UNITED STATES PATENT AND TRADEMARK OFFICE

Office Action Summary

10/554,404

DETAILED ACTION

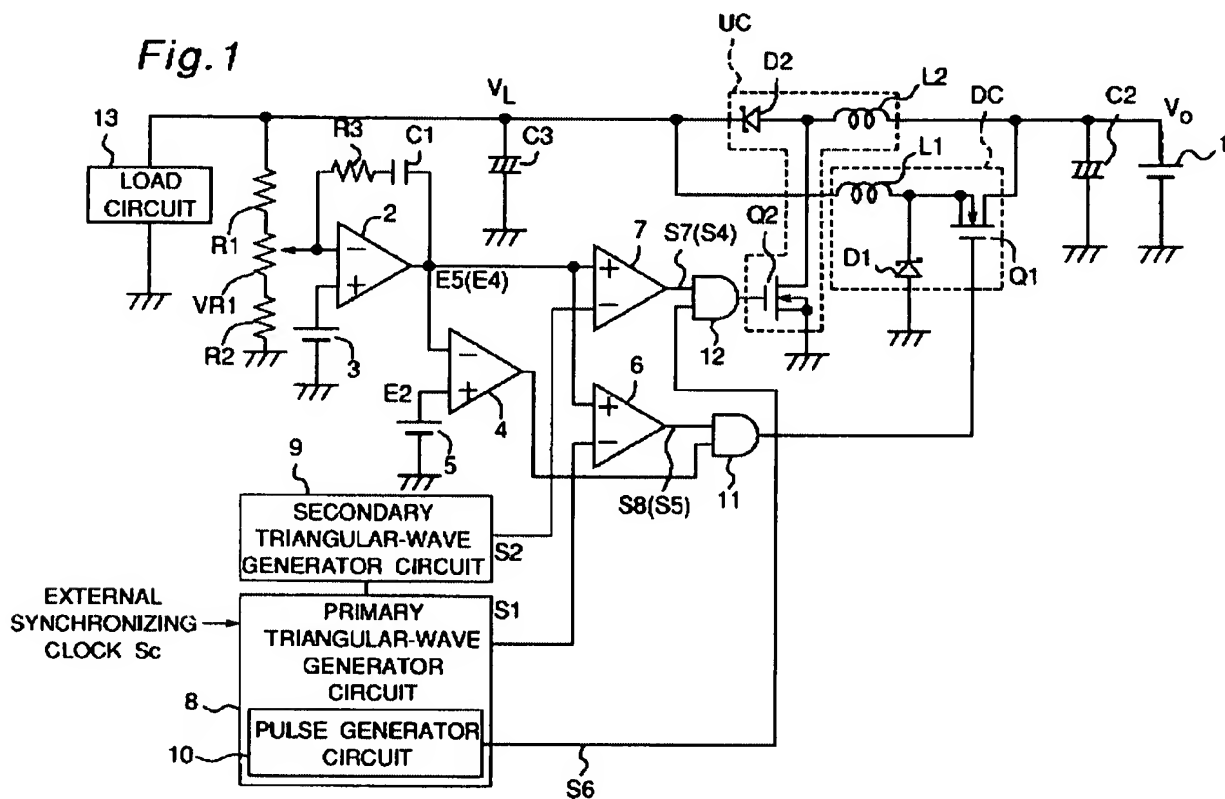
"Furthermore, Yasuda et al. discloses that the output battery voltage V_o is not divided or compared to a reference voltage, rather it is output directly. See FIG. 1. Applicants respectfully submit that Yasuda et al. does not disclose, teach, or suggest, as recited in claims 1, 7, and 13-14."

One of ordinary skill in the art readily recognizes that the battery voltage V_o in figure 1 is NOT the output. This is evidenced by the fact that element 13 illustrates "LOAD CIRCUIT" (13). Hence, V_o is the INPUT and not the OUTPUT. Load circuit 13 is the output. Therefore, the output is divided by R_1 , R_2 and compared to a reference 3.
